From: DiSalvo, Rick
Sent: Tuesday, March 30, 2010 6:10 PM
To: 'Carl.spreng@state.co.us'
Cc: Surovchak, Scott; Kaiser, Linda
Subject: Draft CR 2010-02 Dam Breach Excavation
Attachments: DRAFT RFLMA CR 2010-02 Excavation to Breach Remaining Dams 033010.doc

ROCKY FLATS SITE REGULATORY CONTACT RECORD

Purpose: Approval of Excavation Greater Than 3 Feet Below Grade to Breach Dams A-3, A-4, B-5, C-2 and the Present Landfill Dam.

Figure 1. Monitoring and Dam Breach Locations—Woman Creek Drainage Area

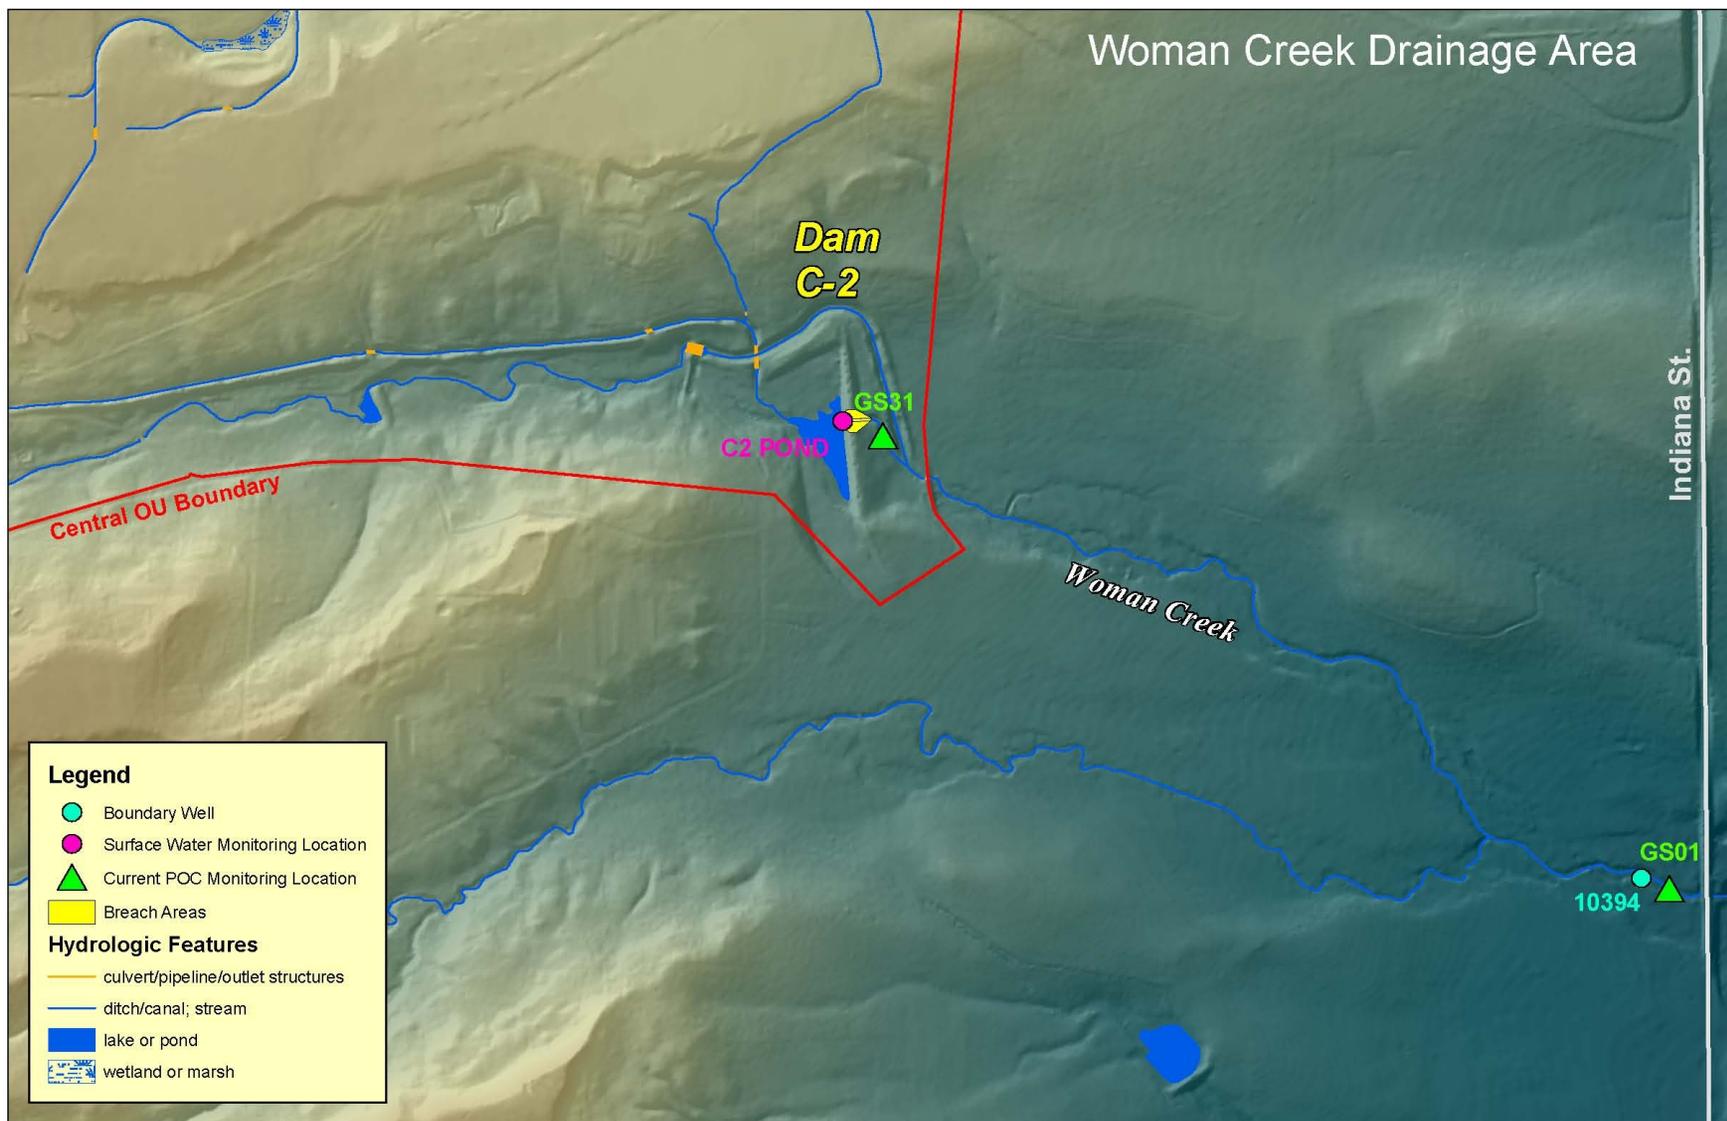
For this CR, Figures 1 and 2 have also been revised to remove the location of the proposed new POCs.
